**City of Fairhope
Planning Commission Agenda
5:00 PM
Council Chambers
February 3, 2025**

A. SR 25.02 Request of the Applicant, Benjamin Cummings, acting on behalf of the Owner, Fairhope 9 LLC, for Site Plan Approval of Harvey and Thomas Orthodontist on property zoned B-2 General Business District. The property is located at the northeast corner of Highway 181 and Highway 104, Lot 9 and is approximately 1.0 acres.
PPIN#: 627499

B. SR 25.03 Request of the Applicant, Chris Lieb, on behalf of the Owner, FST Encounter Development LLC, for Site Plan Approval of Foosackly's. The property is approximately 0.20 acres and is zoned B-2 – General Business District. The property is located at the northeast corner of Highway 181 and Highway 104, Lot 4 and is approximately 1.0 acres.
PPIN #: 627494

C1.0

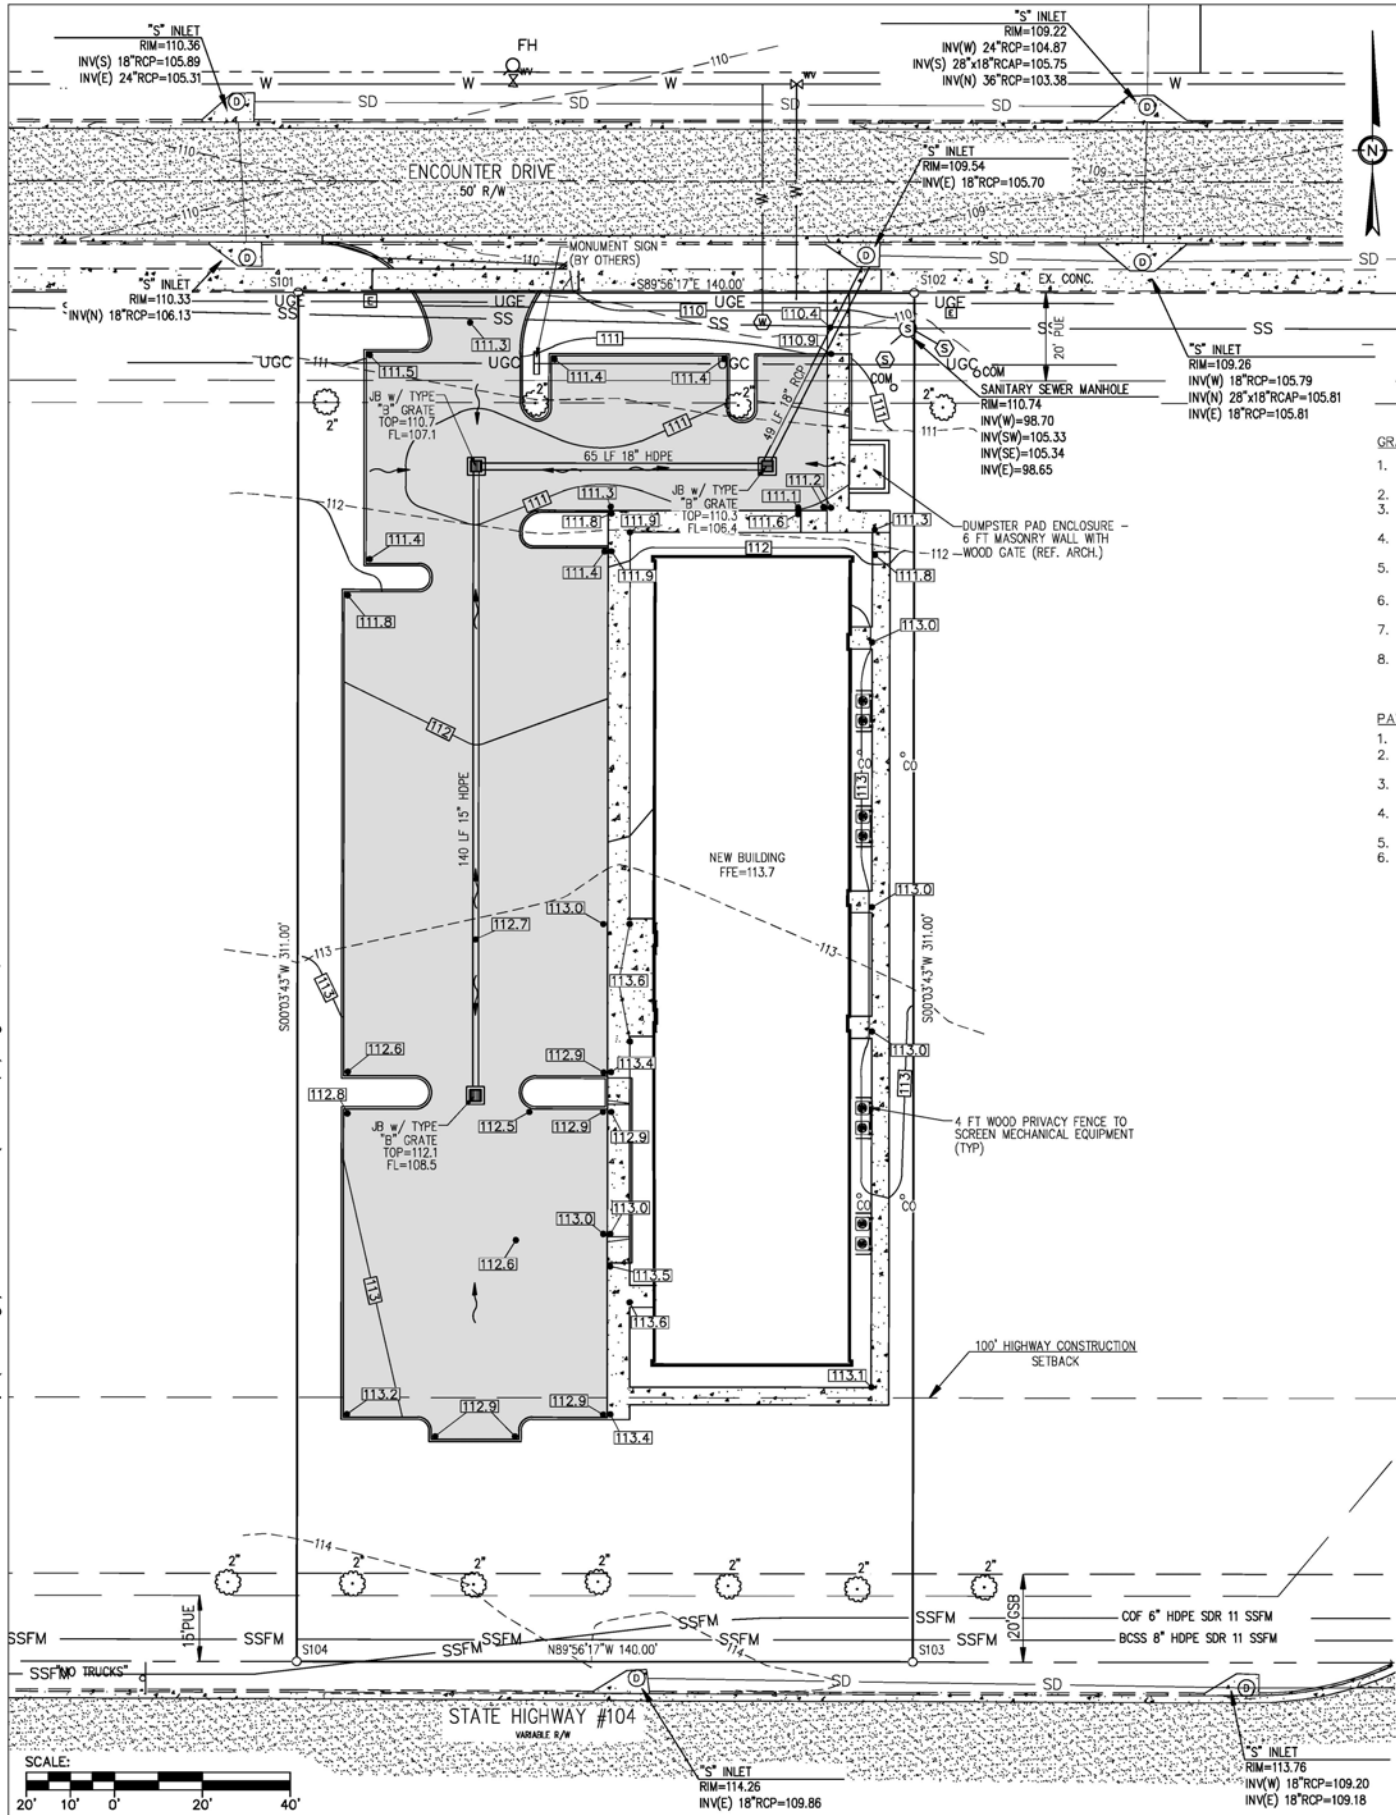
1. On Site Data Table correct the highway construction setback off AL Hwy 104 to 100ft (not 125ft).
2. Update photometric plan with 10ft high lighting.
3. Add Slide No. "S 2963-A" to the Legal Description on Sheet C1.0.
4. Applicant shall attend a utility meeting with the City of Fairhope on February 6, 2025. Said meeting must take place prior to Site Plan going on City Council agenda.
5. Landscape Plan needs to be updated:
 - a. to reflect shrubs being 48 inches tall at time of planting
 - b. Additional shrub along Encounter Drive right of the entrance (looking to the North).
 - c. Additional overstory tree along Encounter Drive right of the entrance (looking North).

C4.0

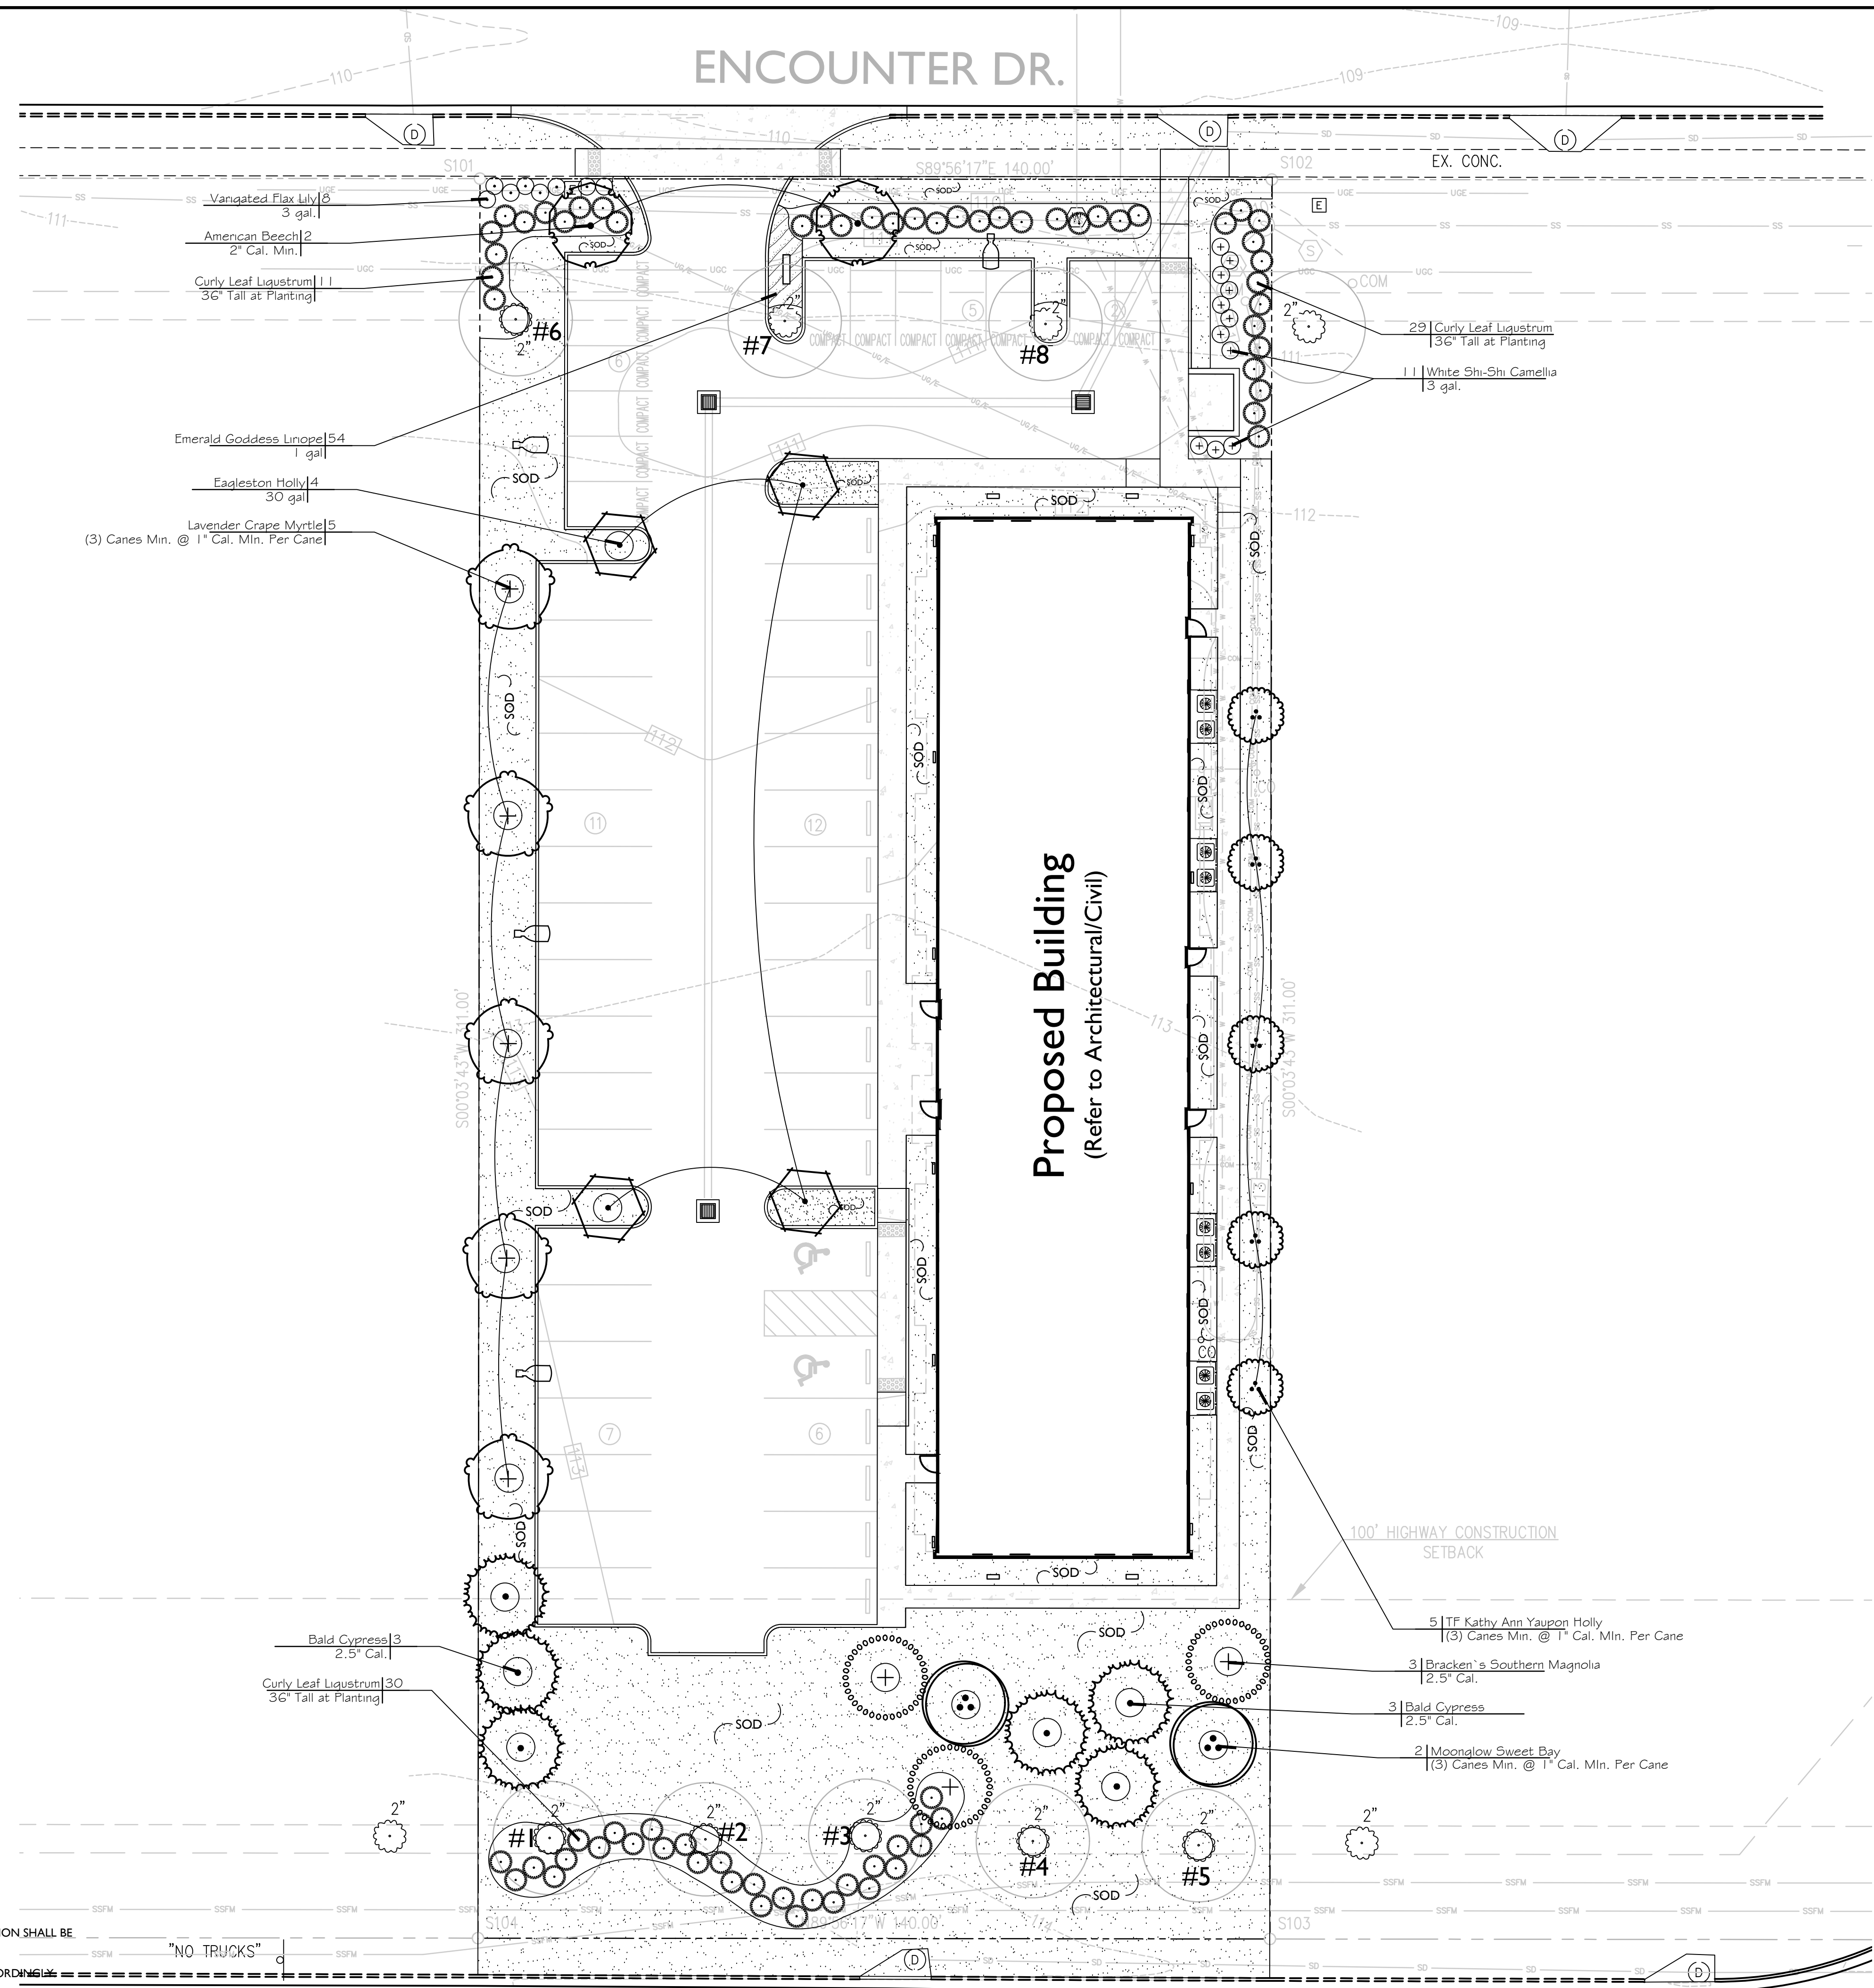
Landscaping Plan: Open or Landscape Area makes up 38% of the site. There is a gap along the Encounter landscaping strip right of the entrance. There is not any indication on the plans of something going there so unless there is a legitimate reason for the gap then planting another shrub should remedy the broken visual screen. In addition, another overstory tree should be planted in that same section pursuant to Section 20.5-5 of Ordinance #1444. *See below.*

Also, plantings must be 48 inches tall at time of planting unless within four (4) feet of an access way; whereas, the Plant Schedule and Landscape Plan have Curly Leaf Ligustrum at 36 inches at time of planting. Update accordingly.

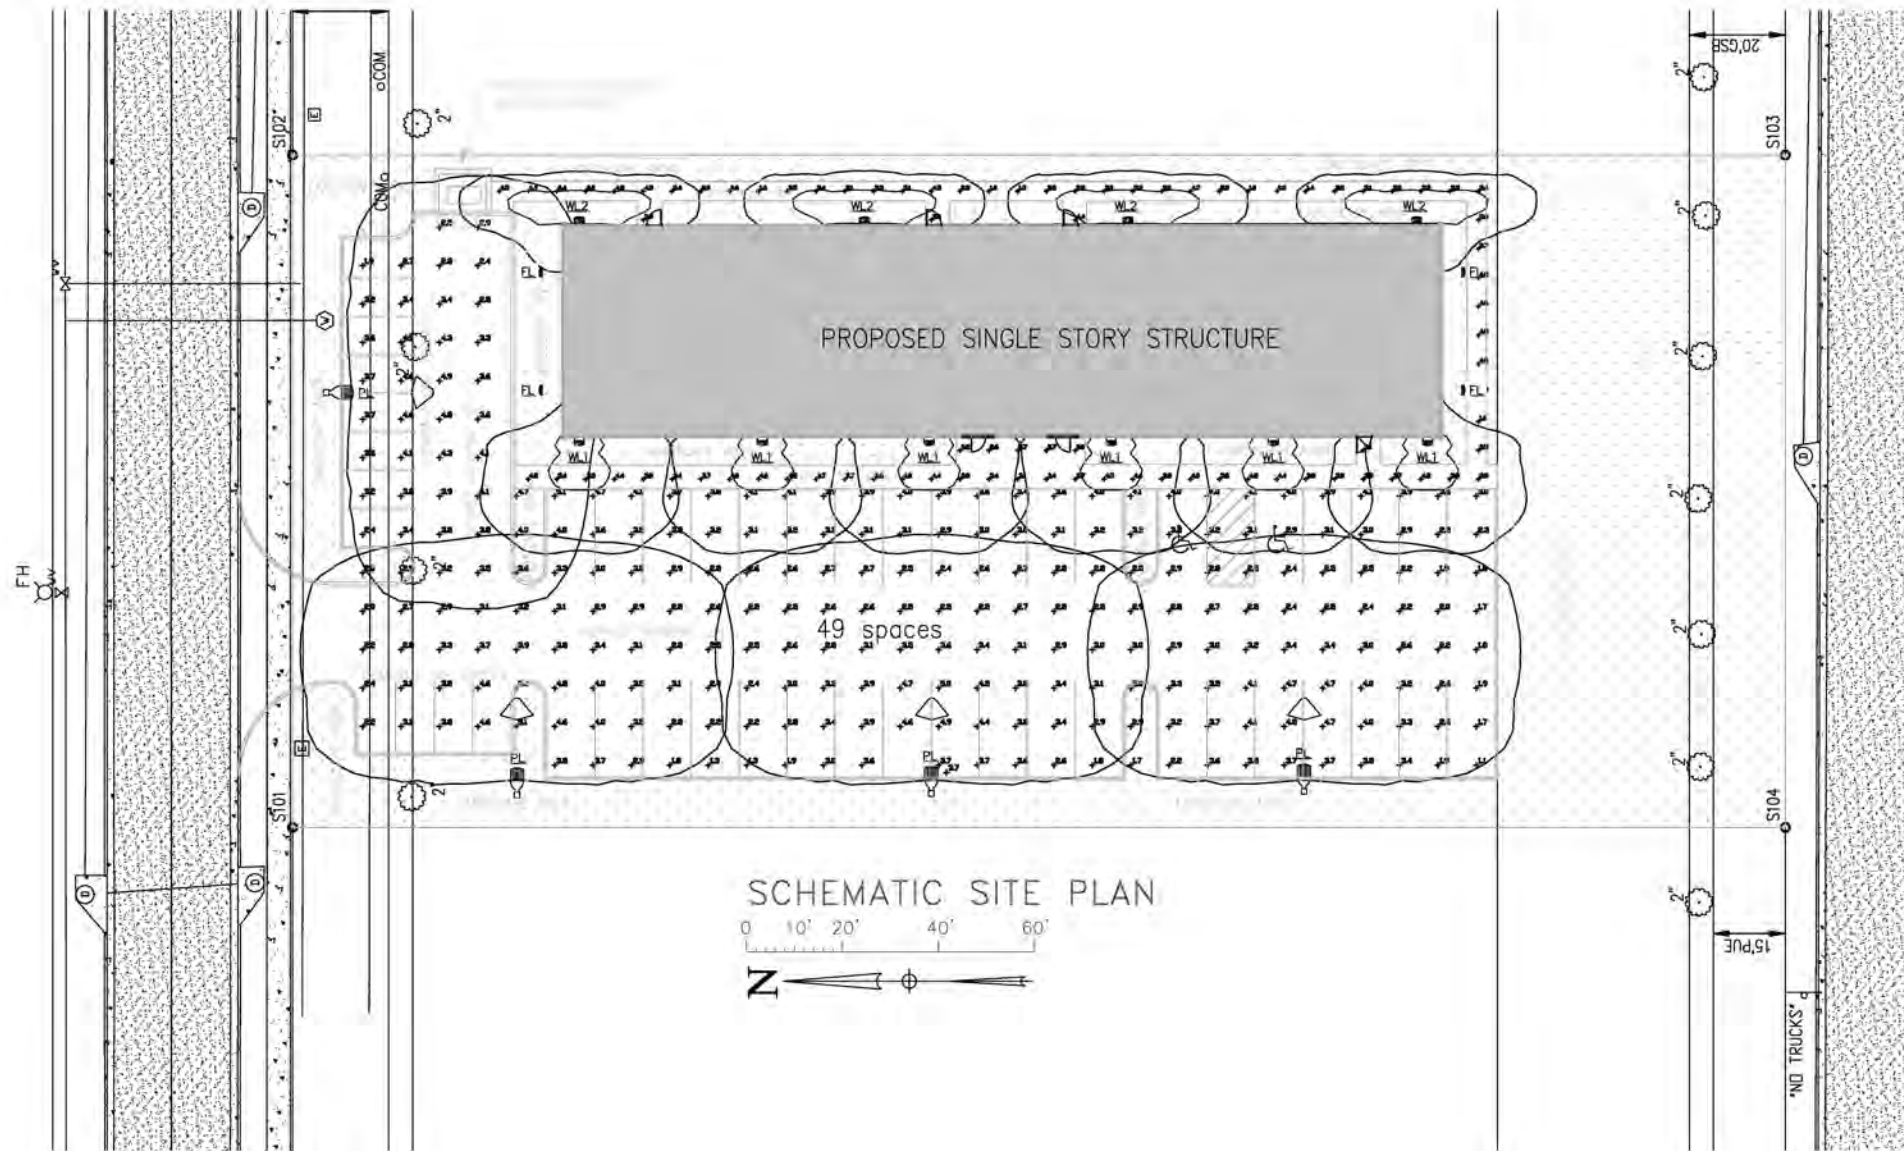
Locations, intensity, and heights of exterior lights: A photometric plan was submitted with the application on Sheet No. ESP-1. The sheet does not have the heights of the light poles. Parking lots with 50 or fewer spaces shall have light poles that do not exceed 10ft overall height pursuant to Article IV, Section B(3) of the Zoning Ordinance.
